UNITED STATES PATENT AND TRADEMARK OFFICE

APPLICATION NO.	FILING DATE	FIRST NAMED INVENTOR	ATTORNEY DOCKET NO.	CONFIRMATION NO.
10/721,233	11/26/2003	Yoshiyuki Katoh	019970-010	5685

Office Action Summary

DETAILED ACTION

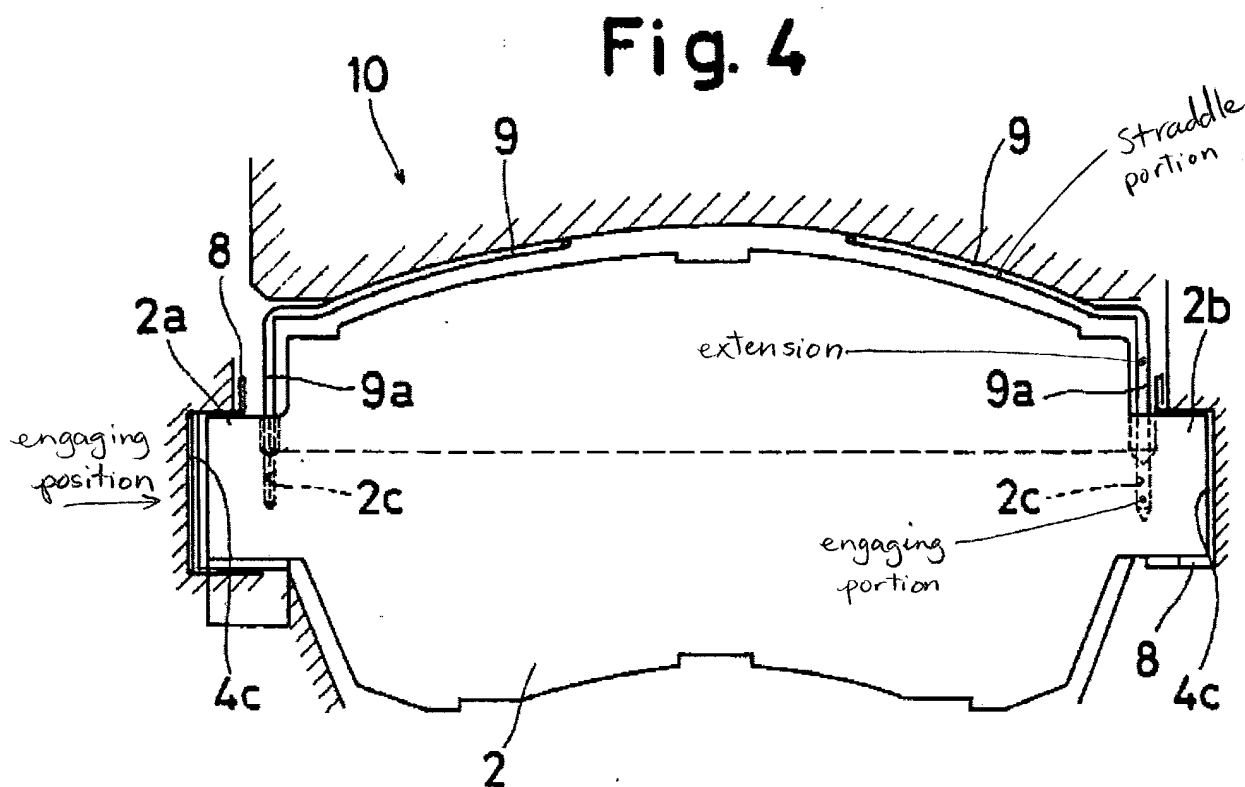
Re: claim 1, Tsuruta shows a disk brake assembly, as in the present invention, comprising: a disk rotor 1 having a central axis; a pair of friction pads 2,3 arranged and constructed to be pressed against the disk rotor from opposing sides in an axial

direction of the disk rotor and a return spring 9 coupled to the friction pads and arranged and constructed to bias the friction pads in directions away from the disk rotor, wherein: the return spring includes a straddle portion, a pair of extensions and a pair of engaging portions, as indicated on the figure below, the straddle portion is disposed radially outside of the disk rotor and extends in the axial direction across the thickness of the disk rotor in order to straddle the disk rotor, each of the extensions extends from the straddle portion, in a direction substantially toward the central axis of the disk rotor, to an engaging position that is proximate to a centerline of one of the friction pads with respect to a radial direction of the disk rotor; each of the engaging portions is disposed at one end of each extension and engages one of the friction pads at the engaging position, as shown in the figure below.

Re: claim 2, Tsuruta further shows a mount 4a arranged and constructed to support the friction pads; and a slide guide device including a first guide portion 4c and a second guide portion 2b provided on the mount and each of the friction pads, so that the second guide portion can slide relative to the first guide portion, wherein: the second guide portion is disposed at the engaging position; and each of the engaging portions of the return spring engages the second guide portion.
